City of Albuquerque

**RE: HOFFMANTOWN BAPTIST CHURCH EXPANSION (E20-D20) DRAINAGE AND
GRADING PLAN FOR BUILDING PERMIT APPROVAL. ENGINEER'S STAMP
DATED 10-13-95.**

RE: GRADING/PAVING PLAN FOR HOFFMANTOWN BAPTIST CHURCH
(E20-D20) ENGINEER'S STAMP DATED 3/3/95.

RE: Hoffmantown Baptist Church New Transformer Location on
Pino Arroyo

CUTOFF WALL FOR BANK STABILIZATION

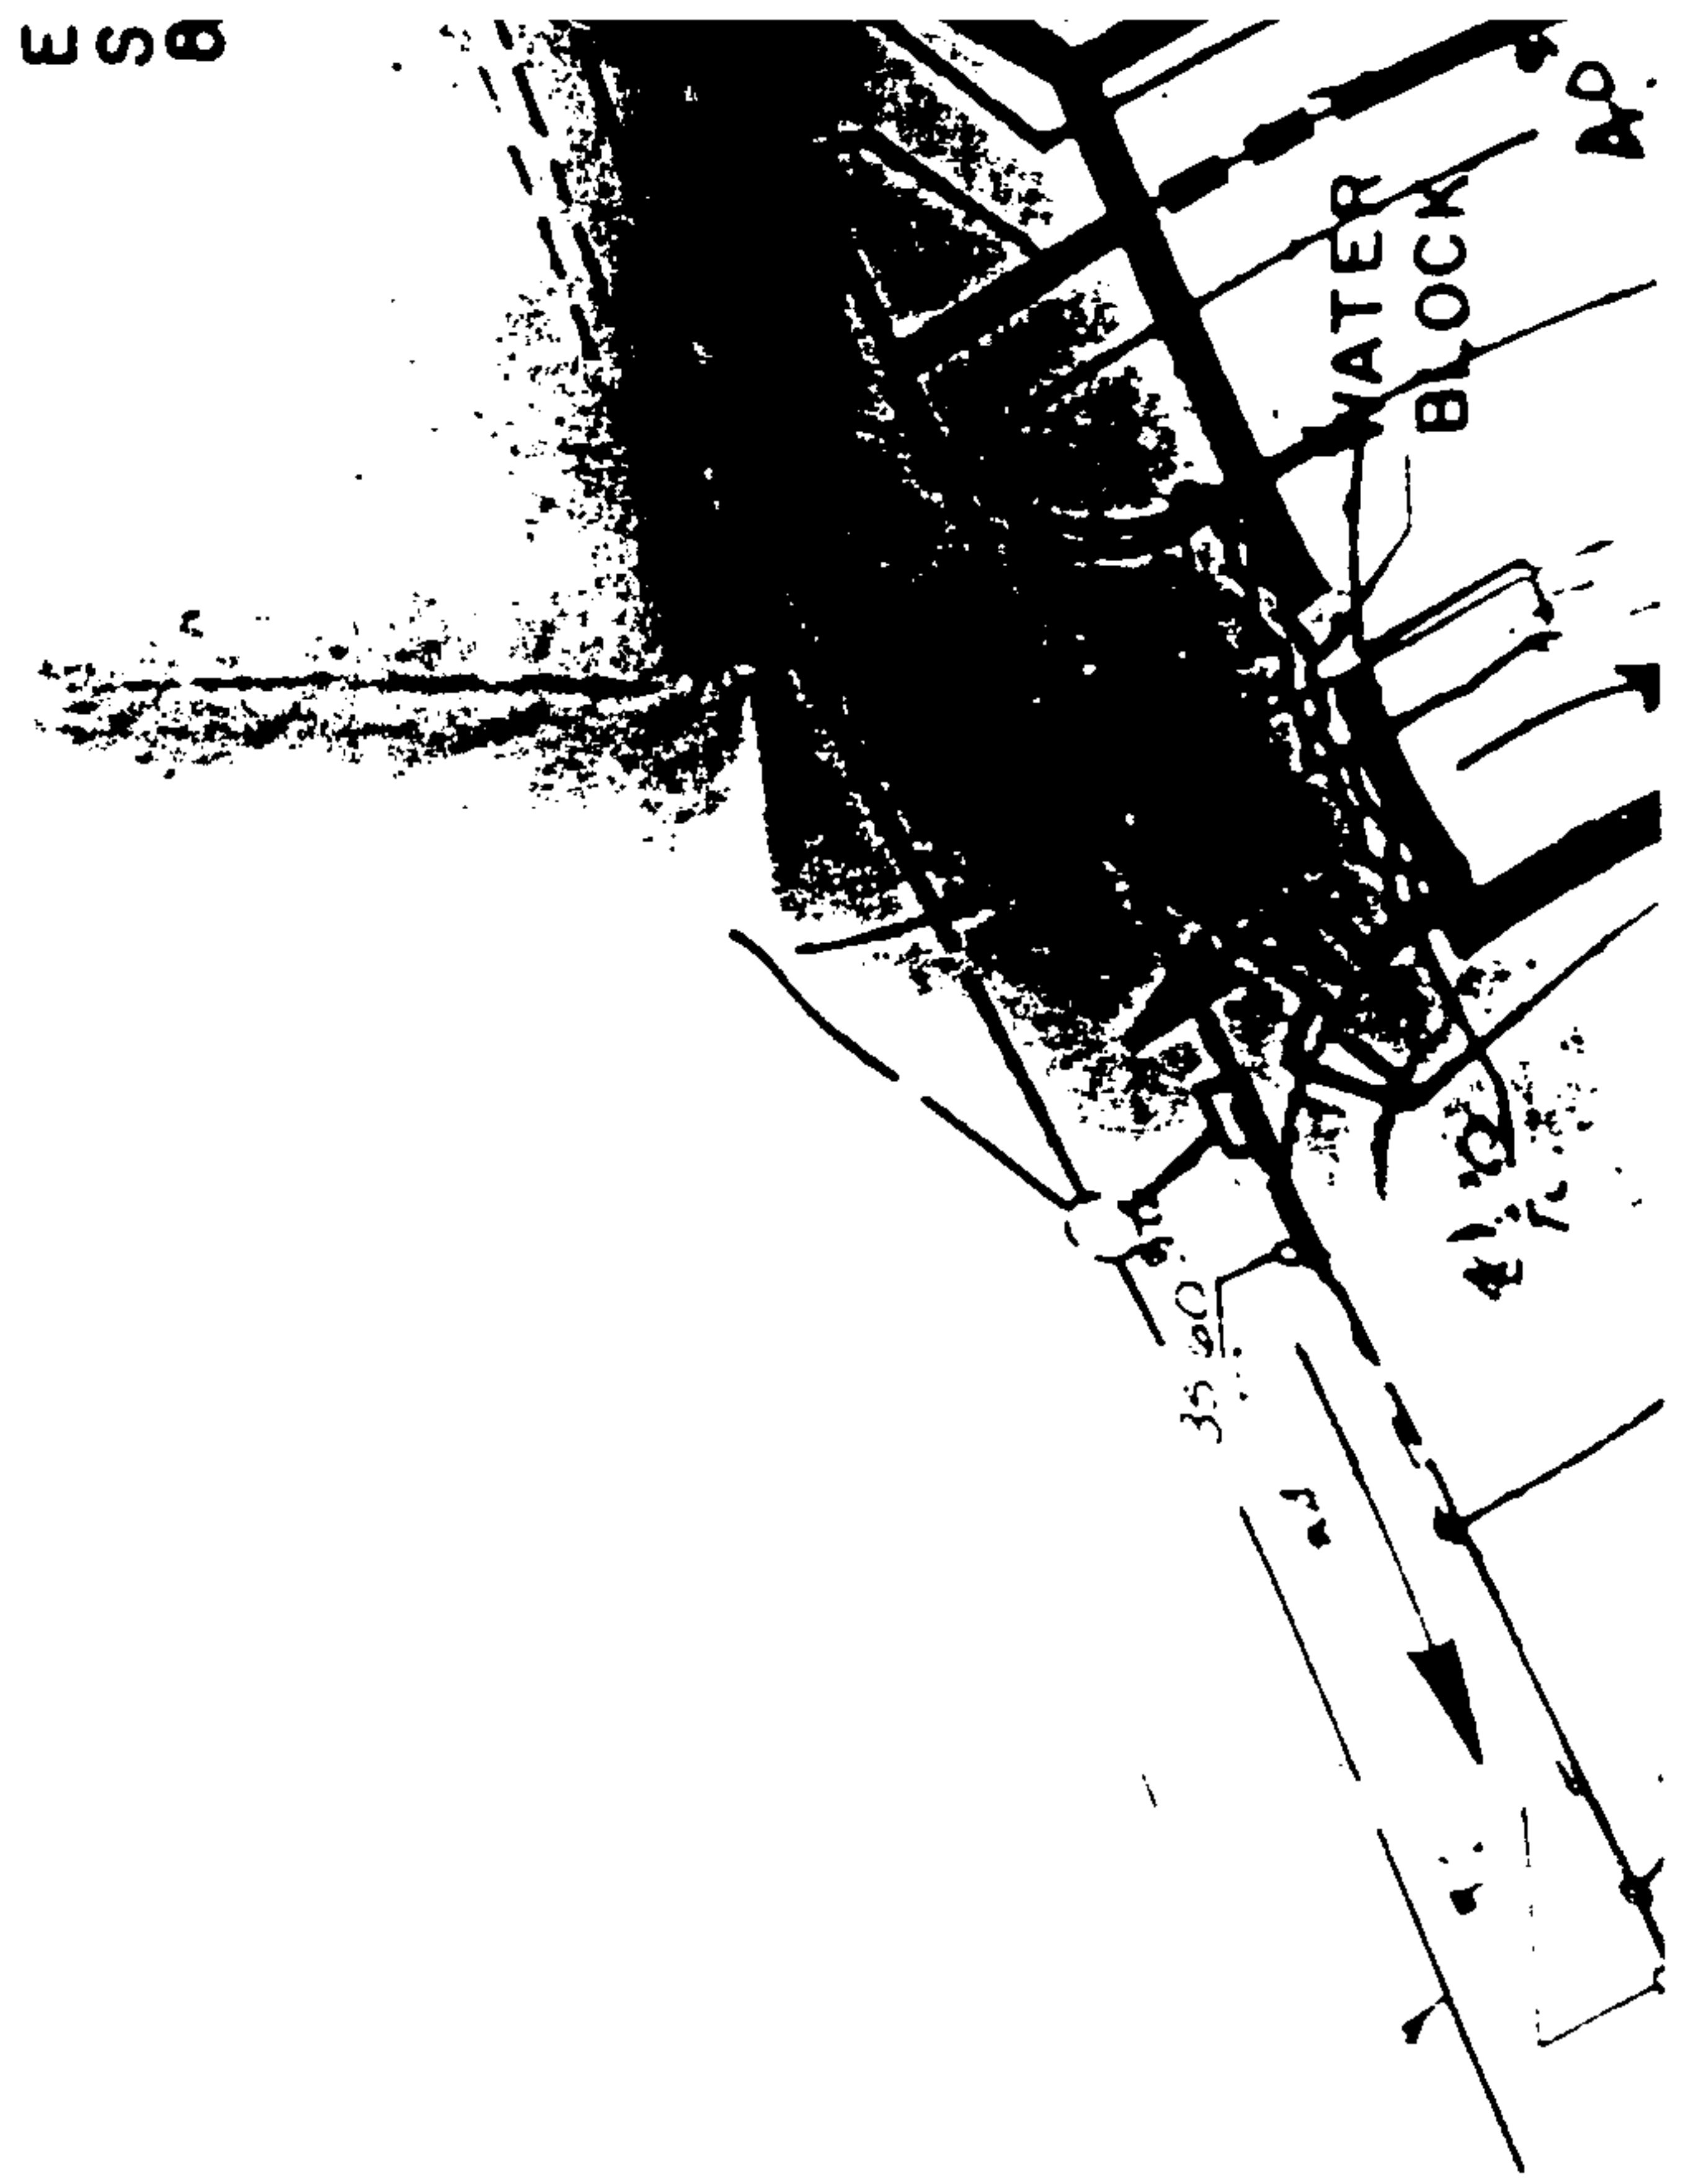
1. There is a soil cement cut-off wall located on the north side of the arroyo. I have attached a copy of the detail. Per the new sediment and erosion design guide (not available when church site was developed in mid 80's), it appears that this wall may not be adequate. The erosion setback probably encroaches and scour may be of concern.
2. The file referenced future permanent improvements to the channel (upon ultimate development) but does not say who will construct these facilities or when. Are there plans for additional development at this site?
3. AMAFCA does not maintain these facilities.
